CITY OF CONWAY, ARKANSAS HISTORIC DISTRICT COMMISSION

August 24, 2026 • 5:30pm • 1111 Main Street

A. 1511 Caldwell St (HDR-0626-0092) Demolition

B. 1511 Caldwell St (HDR-0726-0100) New Single-Family Residence

PROPOSED REBUILD HDR-0726-0100

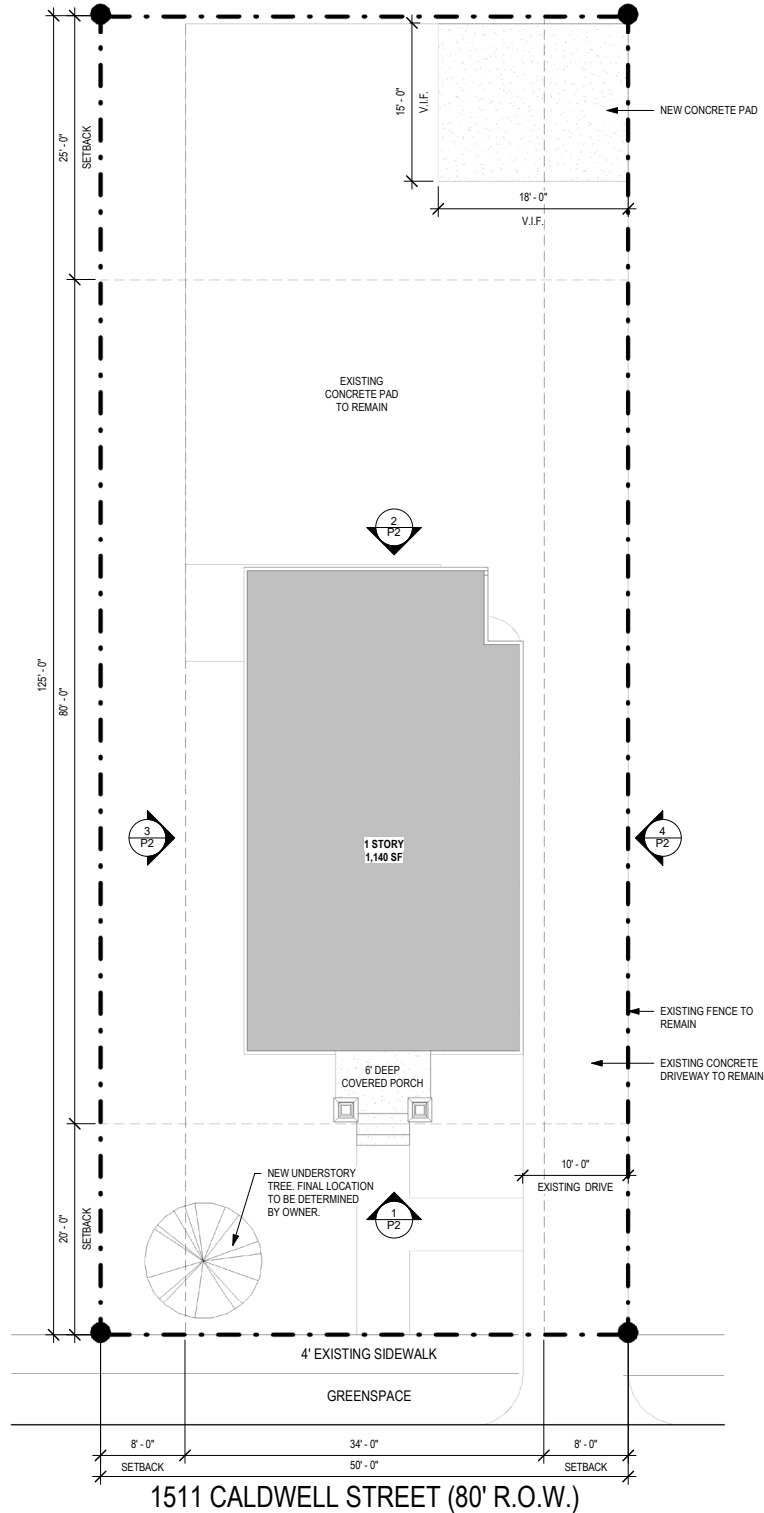
An understory tree is proposed. The property has 50' of street frontage.

The parking/driveway area at the rear of the property will be increased. It will not be obtrusive as it is set at the back of the property and minimally visible.

The site plan indicates that the existing wooden, privacy fence is to remain.

There is an existing ten (10) foot wide, concrete driveway that will be maintained.

The front setback on the original structure was 20'. The proposed front setback for the new build is 20'.

A 13'-6" eastern side yard setback is proposed. A 10' western side yard setback is proposed. This is consistent with the original structure and conforms to setback requirements.

A 52'-1/2" rear setback is proposed. This is comparable to the original structure and conforms to standards.

3. Roofing shall be architectural asphalt shingles.
4. If the existing sidewalk is damaged during construction, it must be repaired.
5. Prior to issuance of a Certificate of Appropriateness the applicant shall provide an updated site plan to planning staff showing any trees to remain in addition to the tree to be planted.

6. There shall be one understory tree planted in the front yard. Any trees over 8" in diameter must be retained in the rear yard outside of the building footprint.

PROPOSED REBUILD HDR-0726-0100

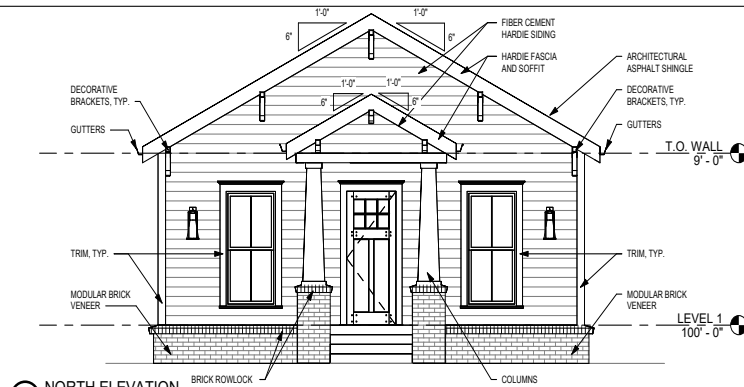
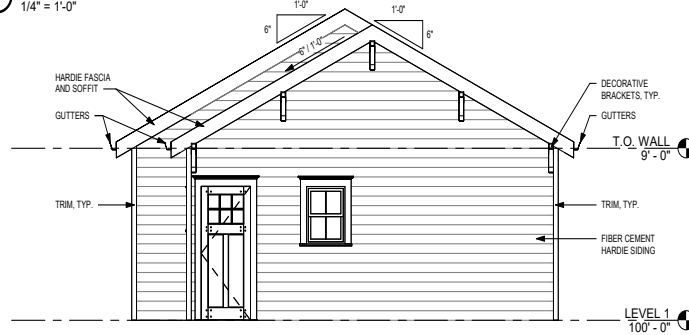
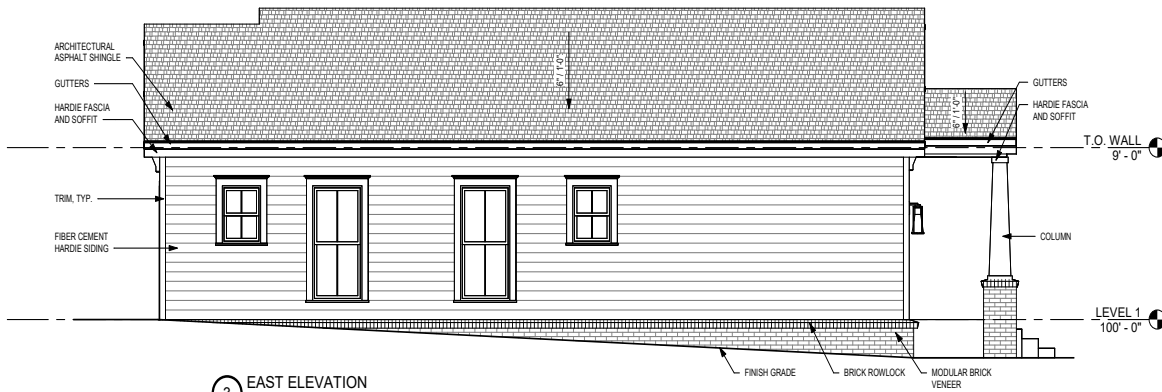
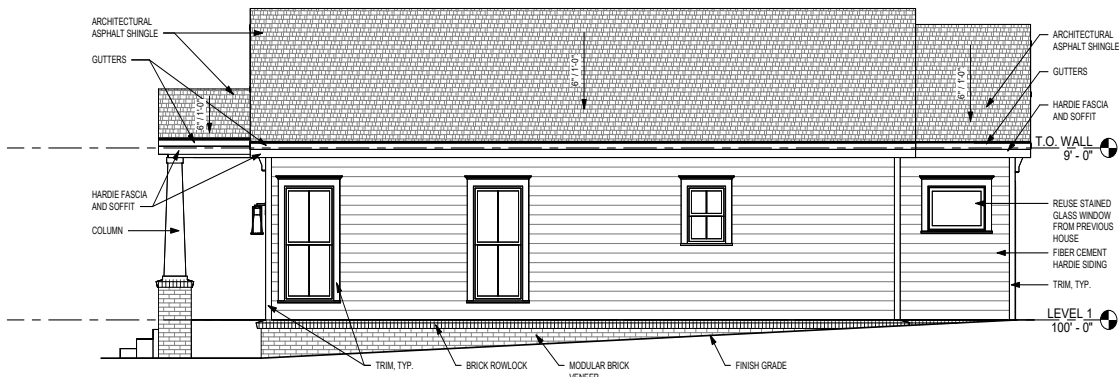
The applicant is rebuilding the residence according to the existing pattern established by the original structure.

Fiber cement Hardie siding is proposed with modular brick veneer skirting, columns, and brick rowlock accents. Architectural asphalt shingles are proposed as the roofing material.

A stained glass window from the demolished house will be reused for the new construction. The material type of the new windows are not specified on the application. Wooden windows are preferable. There is evidence of vinyl and aluminum windows being used on surrounding buildings. The proposed subdivision, proportion, pattern and detail mimic the original structure.

1. Applicant must obtain all applicable building permits if/when a Certificate of Appropriateness is granted.
2. Siding shall be composed of brick, wood or a wood-like material such as Hardie ® siding/LP® SmartSide ®.

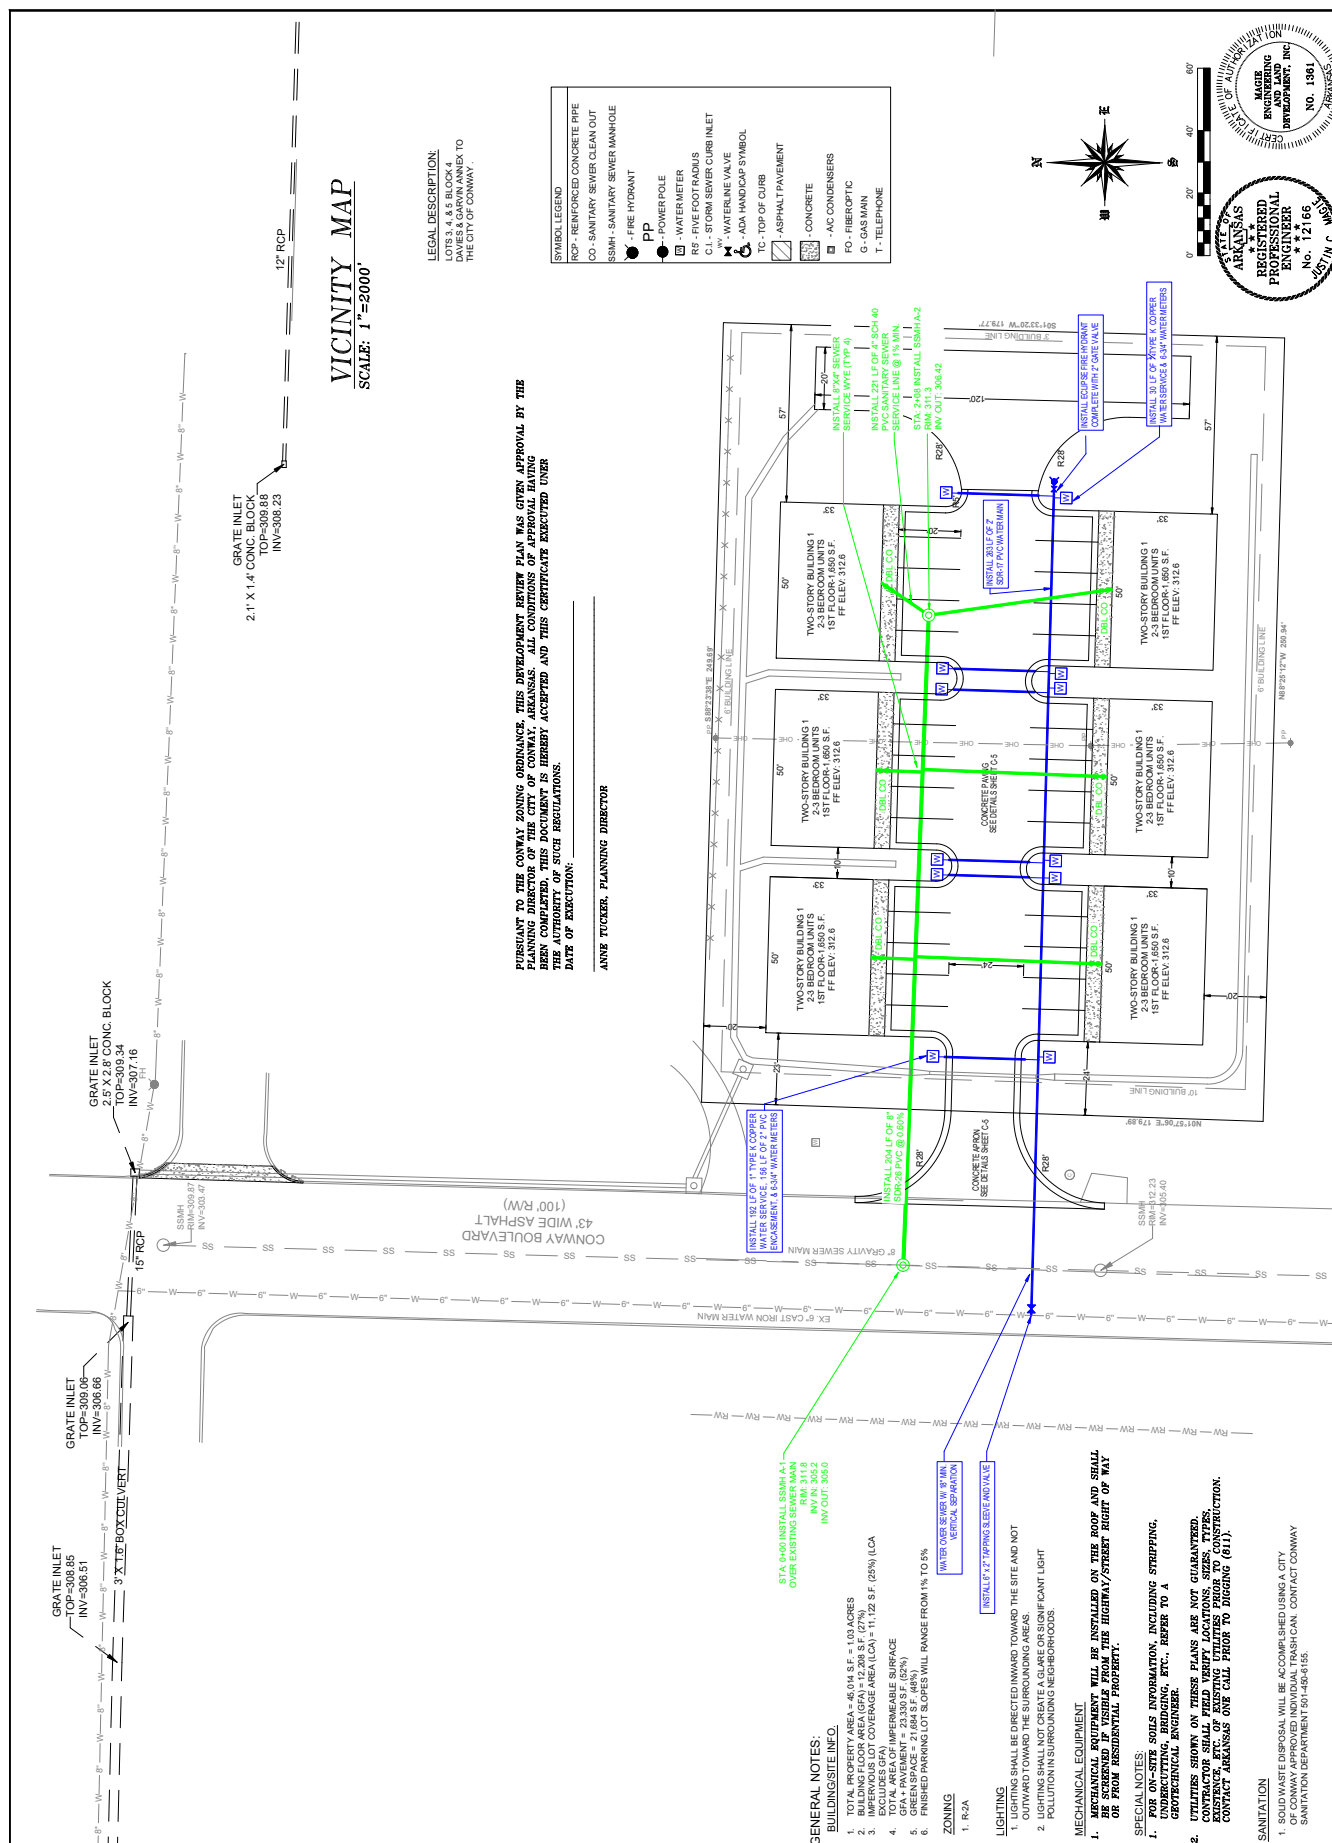
The front doors of the structures face inward to the site and do not follow the orientation of entries along Conway Blvd. Their orientation is to accommodate a centralized driveway and parking area between buildings in a multi-family development. The western elevations could be enhanced to create a more dynamic street facing façade, more characteristic of a front rather than side façade. This could be accomplished with dormers, awning, stoops, and/or a wrap around porch.

There is a shared driveway/parking area internal to the site. The proposed material is concrete. Thirty (30) parking spaces are proposed. According to the Conway Zoning Code, the recommended minimum number of parking spaces for multi-family development is eighteen (18) spaces and the maximum is forty-eight (48). The number of parking spaces is appropriate.

Conway Blvd is a major arterial. The standard sidewalk width on a major arterial is 10' sidewalks with 7.5' of greenspace. The applicant should coordinate with the Conway Department of Transportation to determine the appropriately sized sidewalk for the area, which could be smaller than 10', but in no instance smaller than 5' wide.

No trees are shown on the site plan. There may be some existing trees along the property lines. Existing trees which are not diseased/damaged must be retained. There is 180ft of street frontage. Six canopy trees must be planted along the Conway Blvd frontage. The applicant must also meet the criteria for landscaping in the Conway Zoning Code for Site Development Review.

Shutters are proposed and they must be sized so that they could fit over the windows if operable. The applicant is proposing a gable roof and the roofing material type is not specified.

No HVAC equipment is shown on the site plan.

1. Applicant must obtain all applicable building permits if/when a Certificate of Appropriateness is granted.
2. Prior to issuance of a Certificate of Appropriateness, the following shall be submitted to Planning Staff for review (Additional HDC review may be required):

- Updated elevations with directional labels (north, south, east, west)
 - Additional detailing on the western elevations fronting Conway Blvd, in the form of a dormer, additional windows, and a porch/portico to provide an elevation more characteristic of a front, rather than side elevation

- Porches at least 6' deep
3. Sidewalks with greenspace shall be installed prior to issuance of a Certificate of Occupancy. The required width shall be determined by Conway Department of Transportation and shown on the plans submitted for Site Development Review (SDR).

SECONDARY OPTION

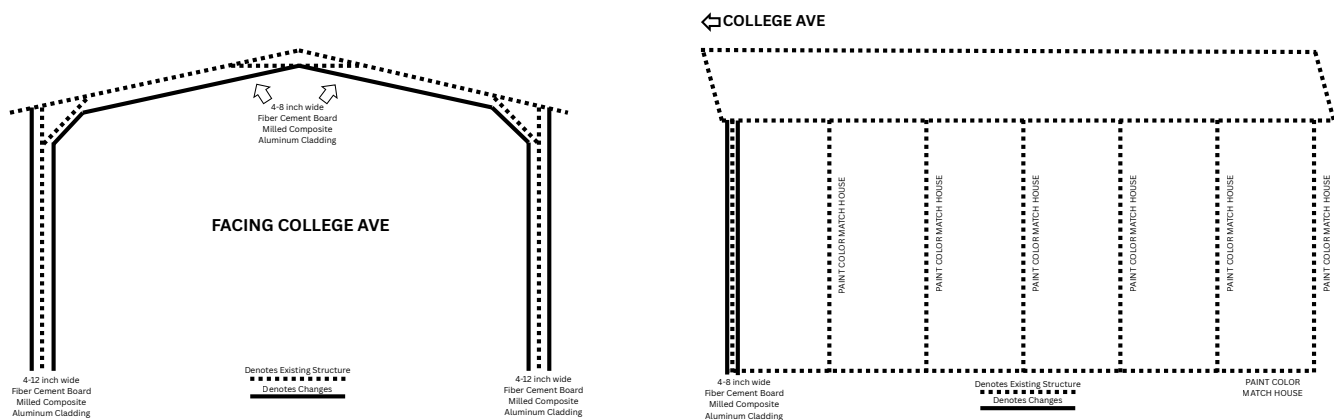
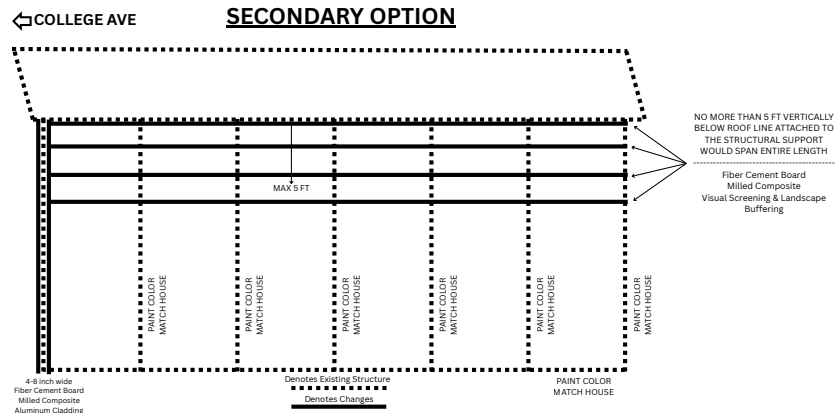
- The building footprint of the accessory structure is greater than 30% of the single-family residence and there is already an existing outbuilding on site
- The material type is generally discouraged

1. The College Ave facing façade shall be clad in fiber cement board as shown on submitted elevations under "Secondary Option".
2. Columns facing side and rear yards shall be painted to match the house as shown on the "Secondary Option".
3. Structural supports shall be added as shown on the "Potential Addition to the Secondary Option".
